SECY-84-87

Subject: NRC REVIEW AND COMMENT ON THE DOE CIVILIAN RADIOACTIVE
WASTE MANAGEMENT PROGRAM MISSION PLAN

NRC COMMENTS

MISSION PLAN

Figure 1. Site characterization - program logic

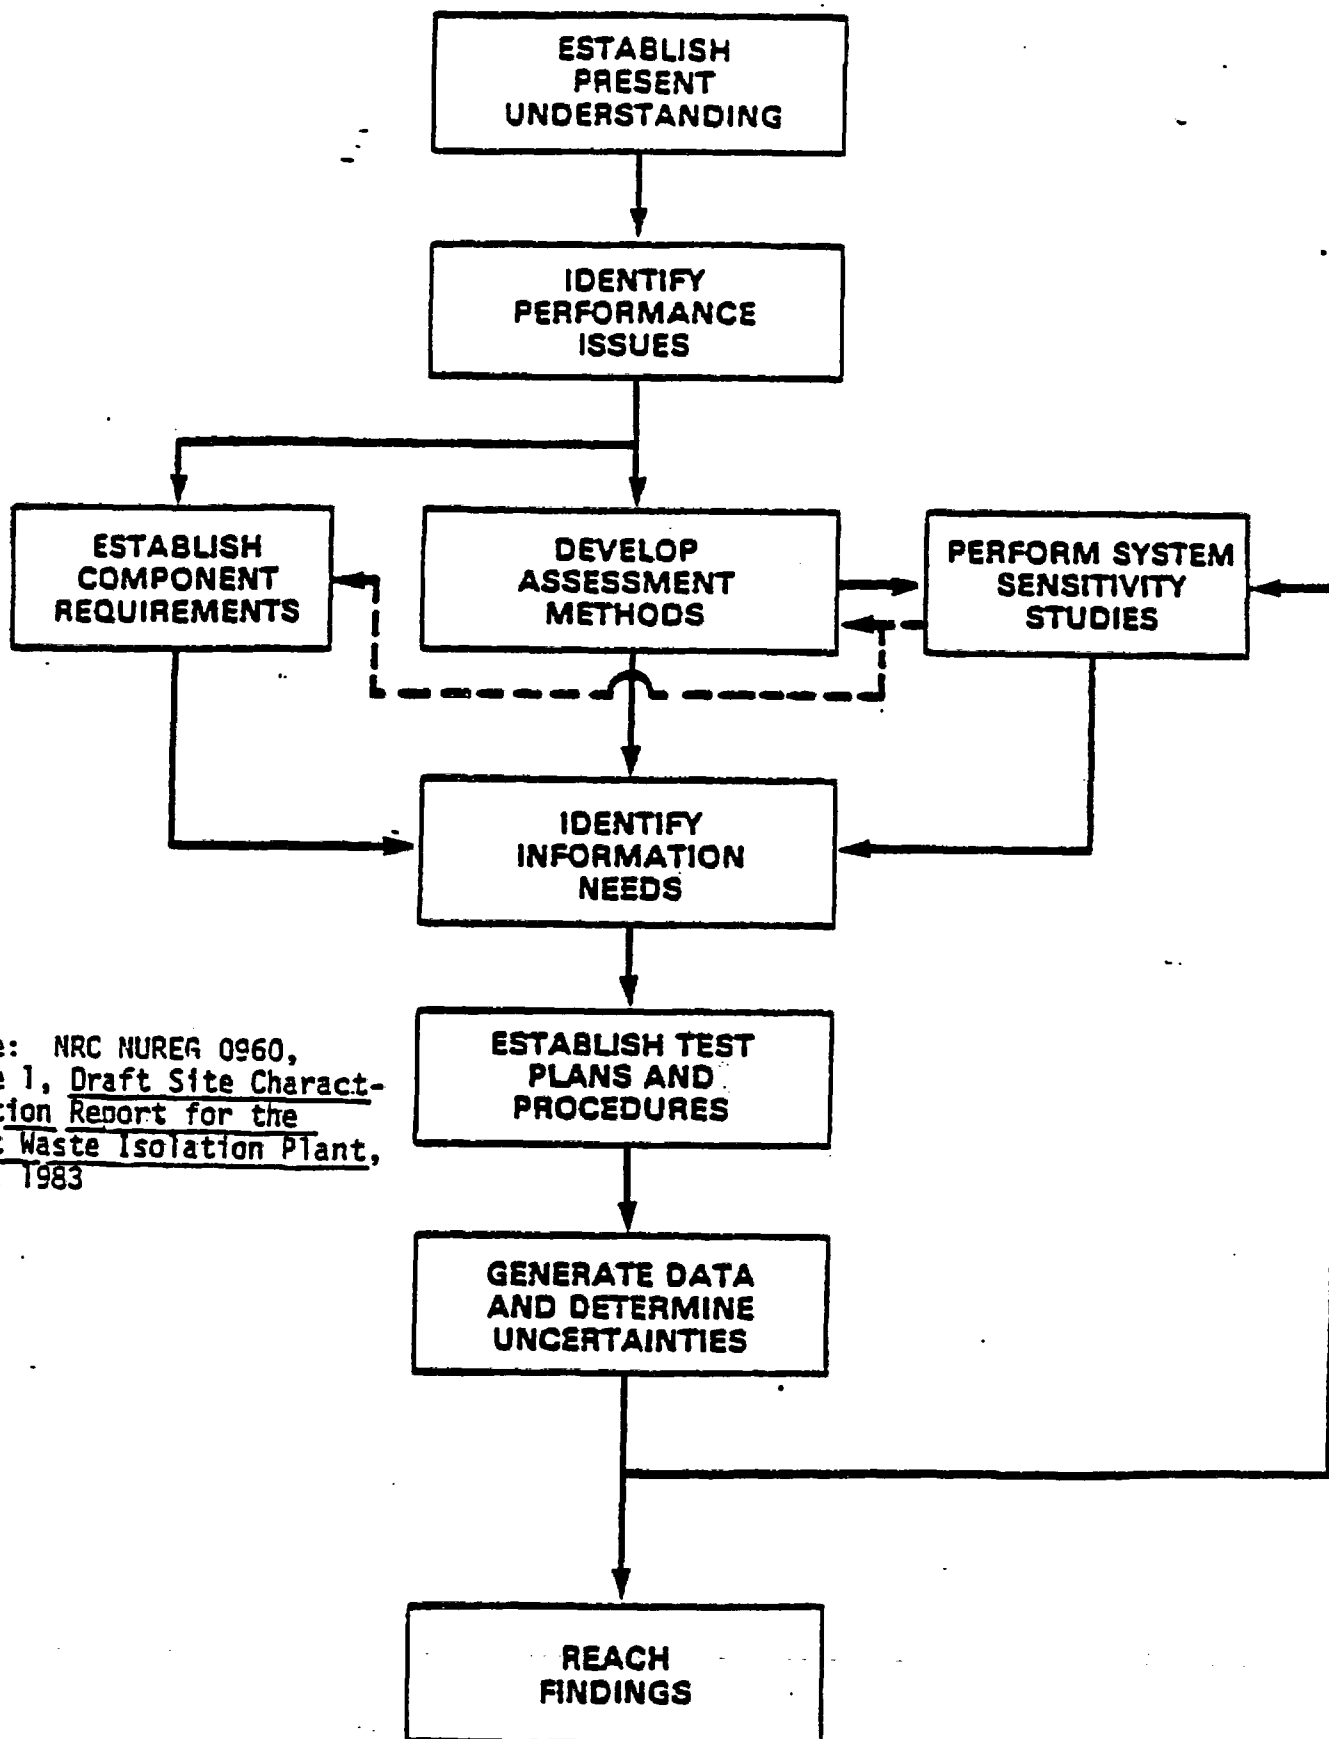
An iterative design process that contains what the staff consider to be the necessary components is described in detail in Chapter 9 of the BWIP SCA and is illustrated in the attached figure. DOE should also consider the discussion entitled, "g. Conditions of Construction Authorization" in the Supplementary Information for the final licensing procedures (46 FR 13976).
